[Docket No. 98-NM-323-AD]

Airworthiness Directives; Boeing Model 757-200, -200PF, and -200CB Series Airplanes Powered by Rolls-Royce RB211-535C/E4/E4B Turbofan Engines

ACTION: Notice of proposed rulemaking (NPRM).

Figure 2.

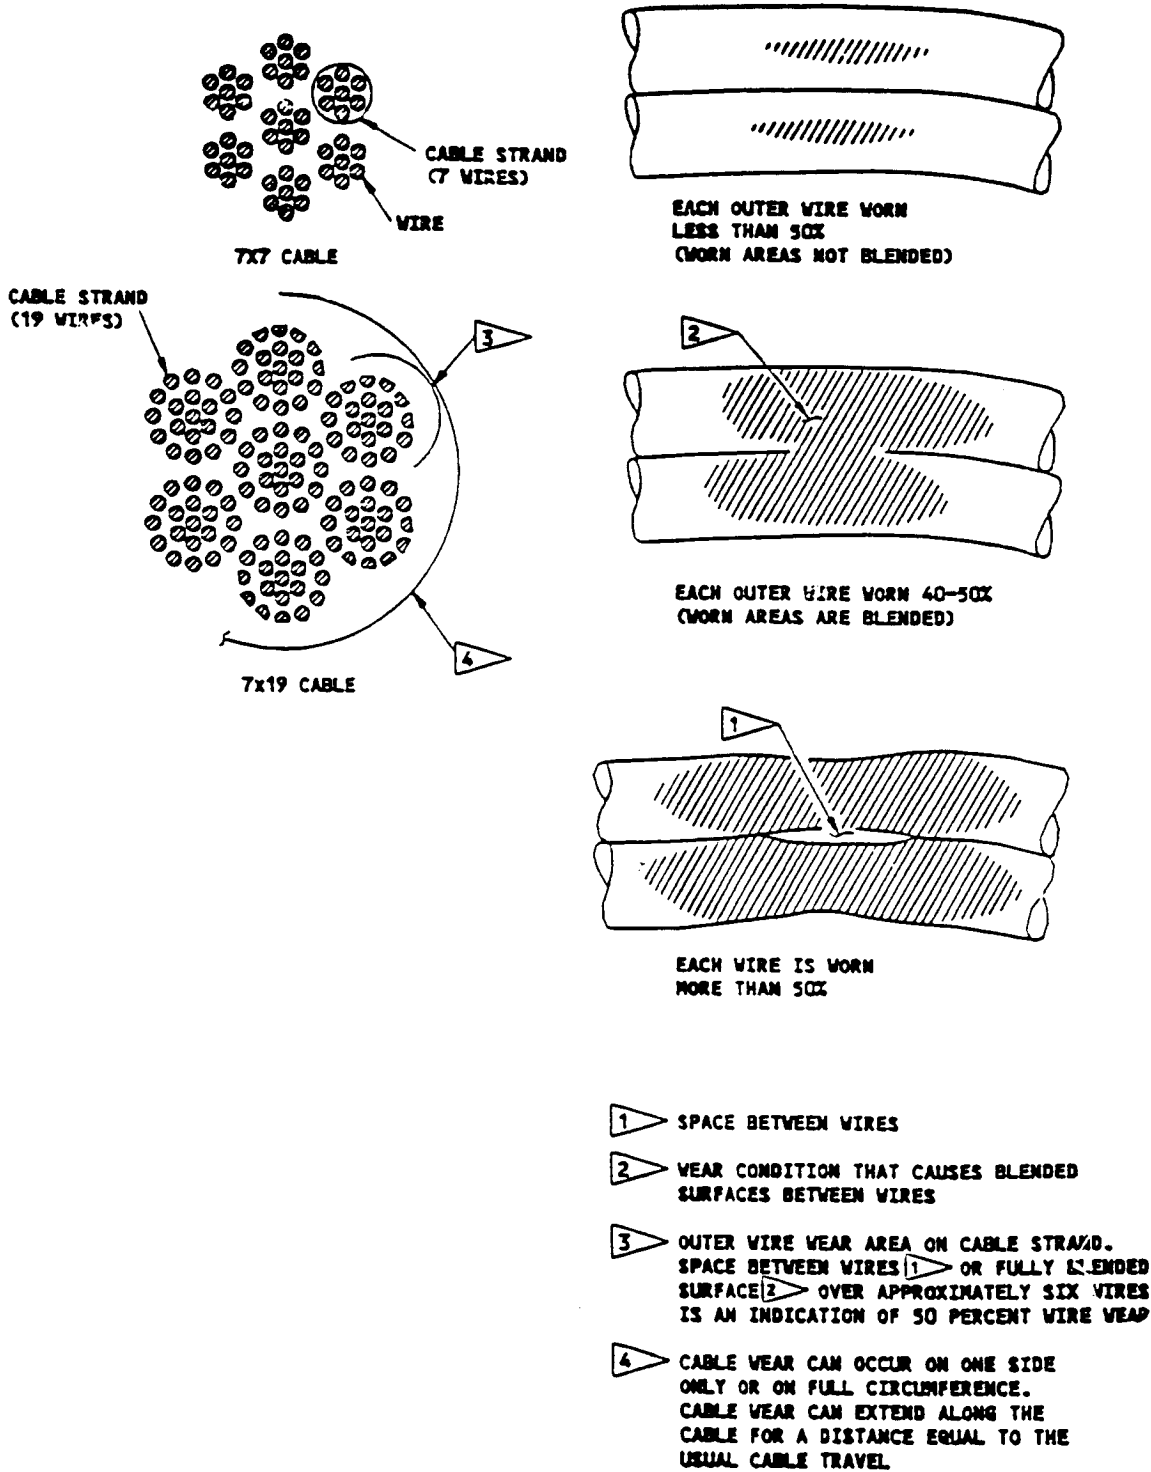
A. Visually examine the pulleys for roughness, sharp edges, and unwanted material in the grooves.

B. Visually examine the pulley wear pattern (see Figure 2).

F. Remove the pulley from the airplane when you find one of these conditions:

(1) An unusual pulley wear pattern.
